MIRAMAR GROVE VILLAGE

SITE
GROVE VILLAGE,
PYMOUTH GROVE, MANCHESTER

DRAWING TITLE
PLANNING DRAWINGS

DRAWING NO
12-01-04

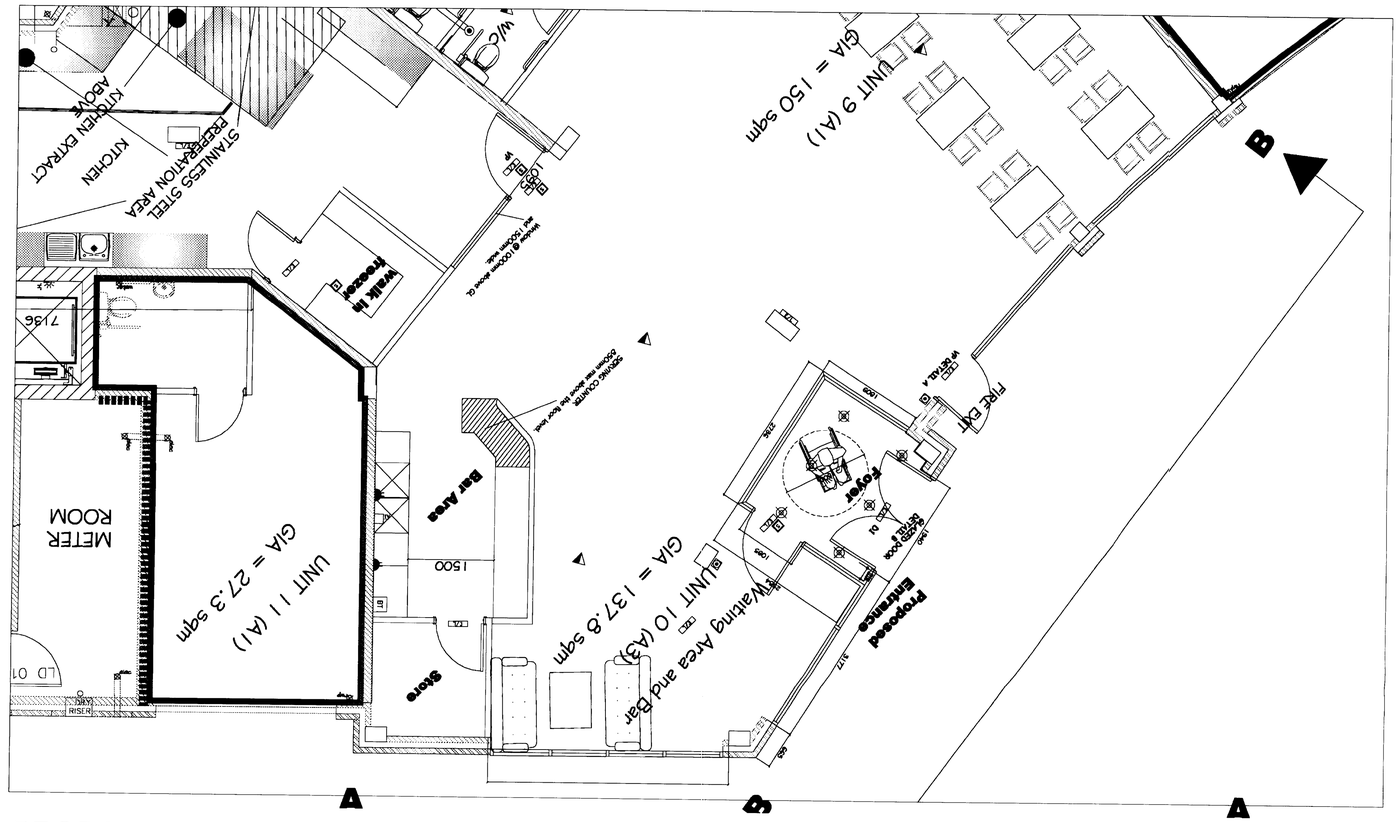
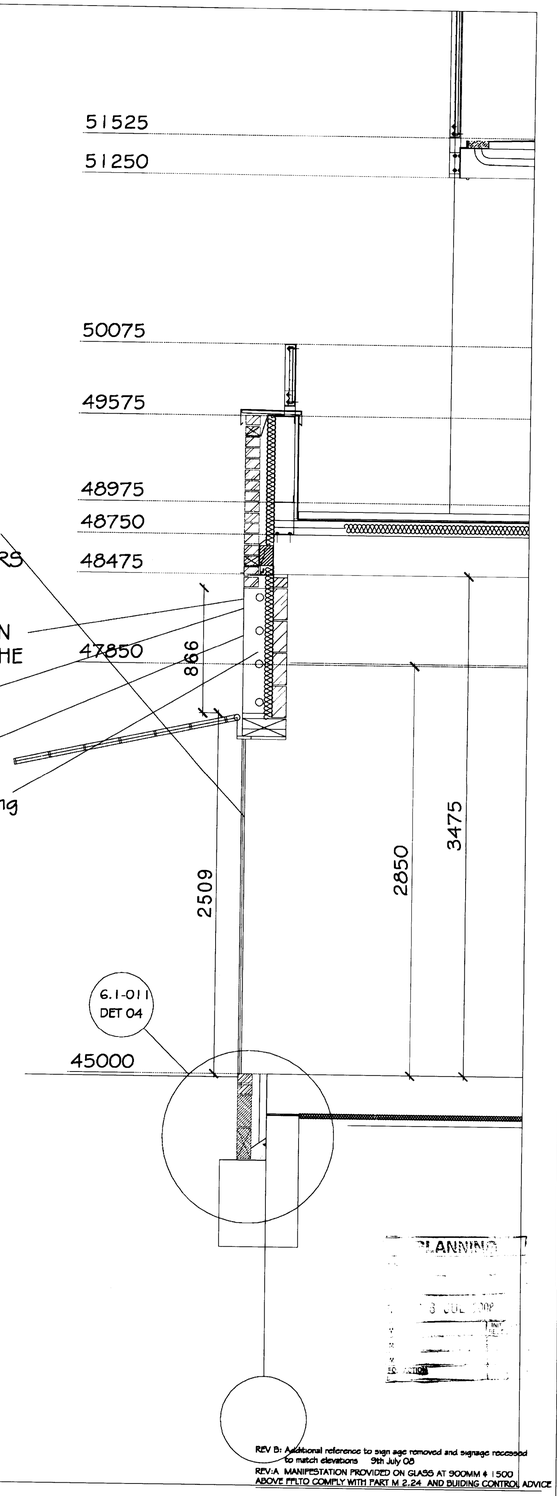
REV B: Additional reference to sign age removed and signage recessed to match elevations Sht July 08
REV A MANIFESTATION PROVIDED ON GLASS AT 900MM & 1500 ABOVE FFLTO COMPLY WITH PART M 2.24 AND BUILDING CONTROL ADVICE
